Model: Finisher SR3280/3290	Date: 4-Mar-19	No.: RD3FN001a
-----------------------------	----------------	----------------

Subject: Check removing the shipping retainer in installation.		Prepared by: H.Kameda	
From: Technical Support Sect., Product Marketing Dept.			
Classification:	<input checked="" type="checkbox"/> Troubleshooting <input type="checkbox"/> Mechanical <input type="checkbox"/> Paper path <input type="checkbox"/> Product Safety	<input type="checkbox"/> Part information <input type="checkbox"/> Electrical <input type="checkbox"/> Transmit/receive <input type="checkbox"/> Other ()	<input type="checkbox"/> Action required <input type="checkbox"/> Service manual revision <input type="checkbox"/> Retrofit information <input type="checkbox"/> Tier 2 <input type="checkbox"/> Tier 0.5

Model: Volga-E		Date: 3-Mar-20	No.: RD3FN002
Subject: Part Change Information : WORM WHEEL		Prepared by: Shunsuke Kuramoto	
From: 2nd Tech Support Sec. Service Support Dept.			
Classification:	<input type="checkbox"/> Troubleshooting <input type="checkbox"/> Mechanical <input type="checkbox"/> Paper path <input type="checkbox"/> Product Safety	<input checked="" type="checkbox"/> Part informat

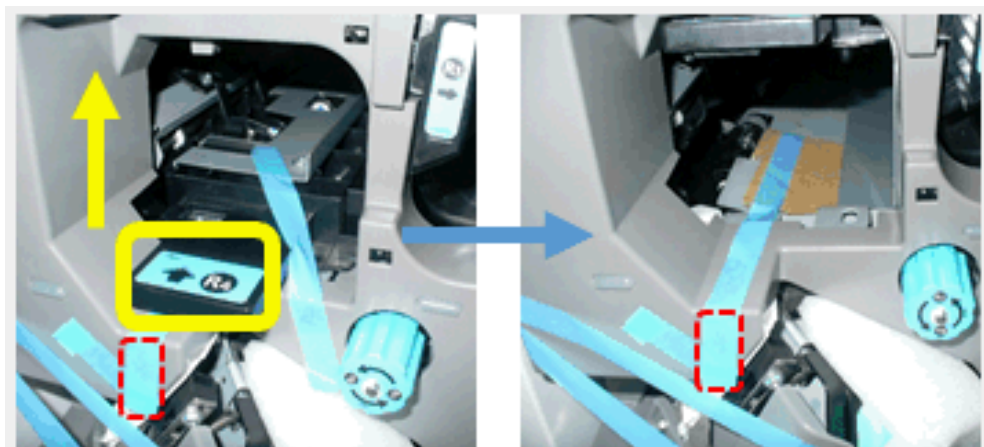
There is a shipping retainer tape under the R4 guide plate and may still be remaining. It cannot be seen unless the R4 guide plate is opened.

Please, check under the R4 guide plate if the shipping retainer tape removed or not. The length of the blue tape extended to be able to be seen without opening the R4 guide plate.

Change

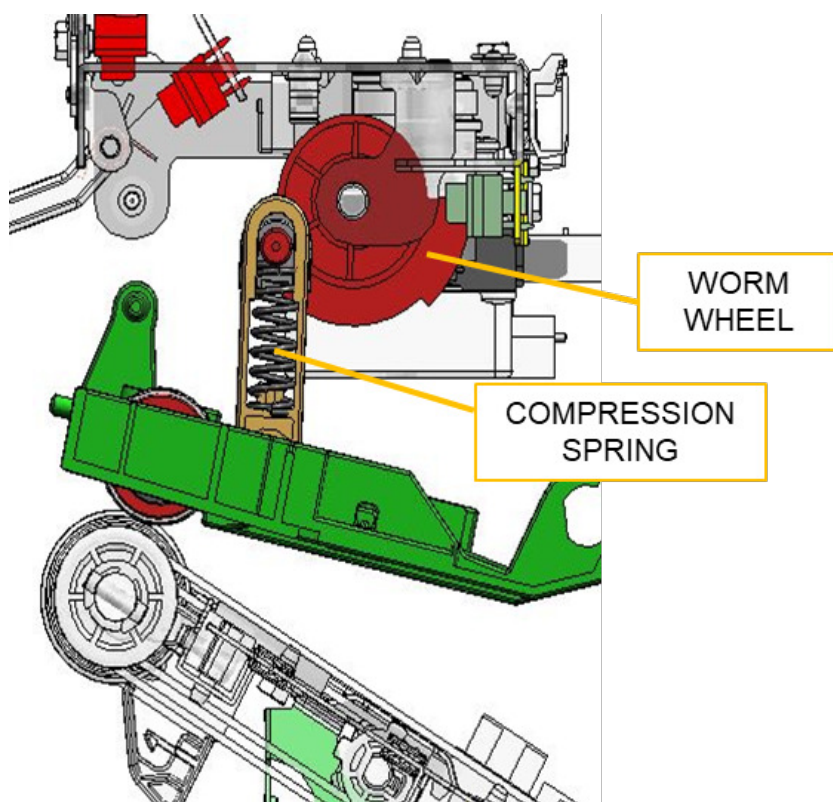
The worm wheel and compression spring have been modified to prevent stapled pages from slipping when they are ejected.

The position of the worm wheel boss and the pressure of the compression spring have been changed.

NOTE: Replace both parts together as a set.
